BULLETIN

NUMBER 55

SUBJECT: Fuel Tank Vents

MODELS AFFECTED: J4E, Serial Nos. 4 1378, 4-1385 and up.
J5, Serial Nos. 5-784 and up.

FIGURE 1 - Install Cap As Shown

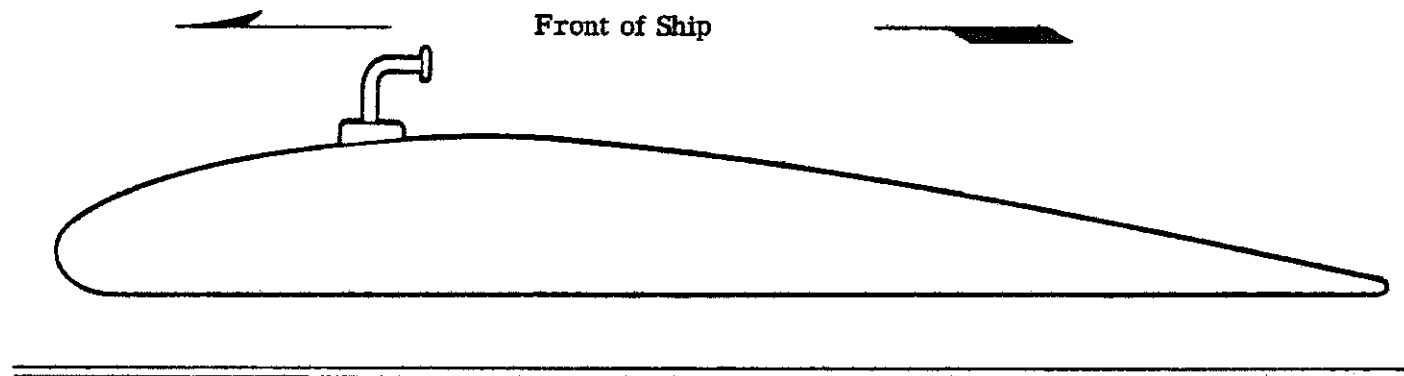
It has been reported by a few owners of the above model airplanes that the engine will not operate properly with low fuel in the 7 gallon header tank.

This condition is attributed to the present wing tank filler cap vent creating a high negative pressure on the surface of the fuel with a resulting loss of effective fuel head.

Therefore, it will be necessary to exchange your present wing tank filler cap vent for a new cap of a different design which will eliminate this trouble.

1. This new type vent must always be installed so that the end with the disk faces to the rear of the airplane as shown on the attached sketch. (See Fig. 1).
2. At the time this cap is to be used on your airplane, the words "FACE VENT TO REAR" must be painted on the wing tank beside the tank filler neck. (See Fig. 2).
3. Upon installation of the new type filler cap, an appropriate entry should be made in the aircraft log book.
